**STAFF RECOMMENDATION**  
**2402 9<sup>th</sup> Avenue South**  
**April 20, 2016**

**Application:** New construction-addition  
**District:** Waverly-Belmont Neighborhood Conservation Zoning Overlay  
**Council District:** 17  
**Map and Parcel Number:** 11801038000  
**Applicant:** Julie Davis  
**Project Lead:** Robin Zeigler, robin.zeigler@nashville.gov

**Description of Project:** The proposal is to demolish an existing stoop on a contributing building and portions of the front wall and to construct a front porch and side lights flanking the main entrance.

Figure 3: Images from early plans books show that the Minimal Traditional style favored small covered stoops over the large porches more typical of turn-of-the-century styles.

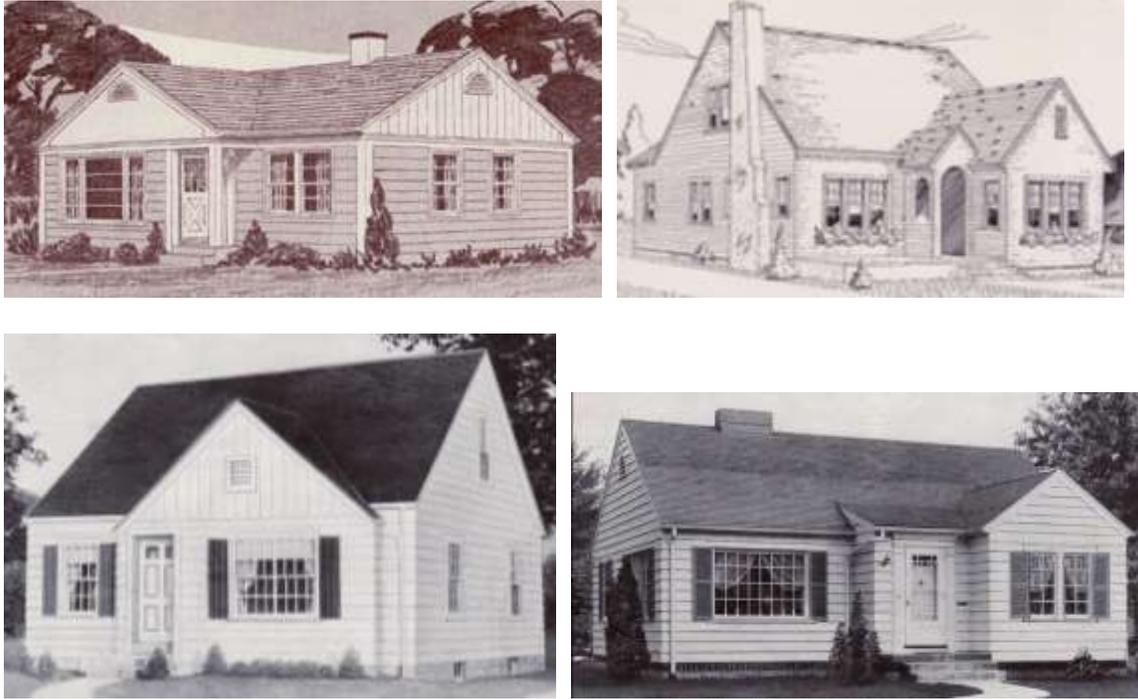
Demolition: The earliest photo known, from 1969, shows the existing covered stoop configuration but with a different post. There is no physical evidence of a different porch configuration or an entrance with side lights. The porch seen in 1969 is typical of the era of construction, which is 1939.

Porches and primary entrances are typically “character defining features” which the Secretary of Interior Standards requires be preserved. For this reason, demolition of the existing porch and the wall to accommodate the side lights does not meet section V.B.1.a. for demolition.

**1 PROPOSED FRONT ELEVATION**

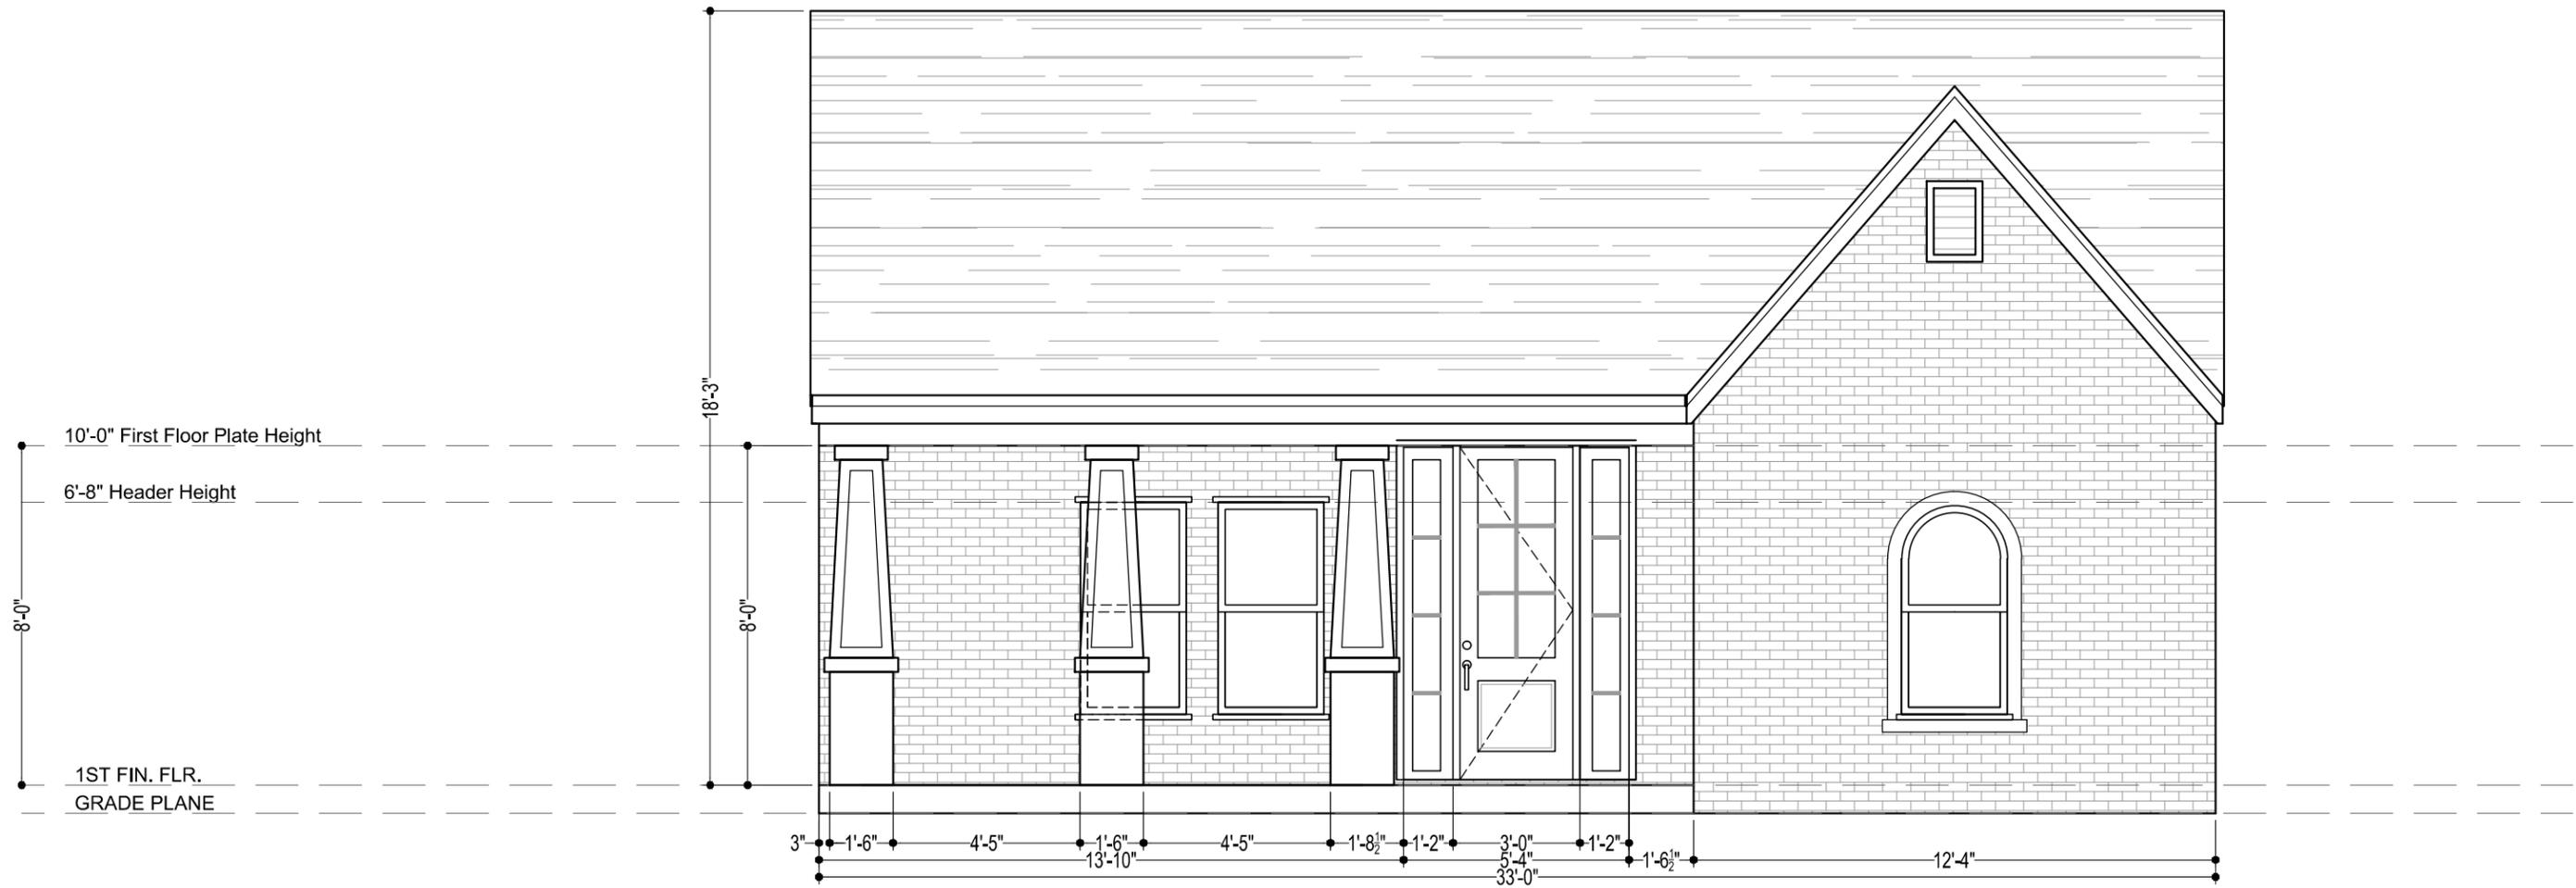
The current proposal includes removing the existing covered front stoop, creating a partial-width craftsman style porch, and adding side-lights to the primary entrance. The drawings show alterations to the front paired windows and the removal of the chimney; however, the applicant states that there are no changes proposed to those two features.

Location & Removability: Generally an addition should be located at the rear of the building in a way that will not disturb the front façade. The proposed porch and side lights is not appropriate as it will alter the design of the front of the historic building. Since the porch addition requires the removal of the existing front stoop it is not possible to remove the proposed porch in a manner that preserves the original look and configuration of the character defining stoop. In addition, the side lights require the removal of portions of the front wall. The project does not meet section IV.A. and F.

a different style and error, rather than utilize a contemporary design. The proposal includes a craftsman-style porch but the house is a Minimal Traditional style home. The craftsman style is typical of the early 1900s and the Minimal Traditional style is associated with the late 1930s and 1940s. The side lights proposed are also more typical of earlier styles such as Colonial Revival and Greek Revival styles and atypical of Minimal Traditional style homes which are known for their lack of detail. The project does not meet section III.E and IV.E.

Roof form: The porch itself is not appropriate, as discussed previously, and the original stoop was a front gable; therefore, the shed roof form proposed is not appropriate. The project does not meet section III.E.

Proportion and Rhythm of Openings: Side lights are proposed to be added to the front entrance. Because this addition will change the original rhythm of openings, Staff finds the project's proportion and rhythm of openings does not meet Section III.G and IV.E.

**Recommendation:** Staff recommends disapproval finding that the demolition of the existing porch does not meet section V.B.1.a for demolition and the proposed porch and side lights do not meet section IV for additions.
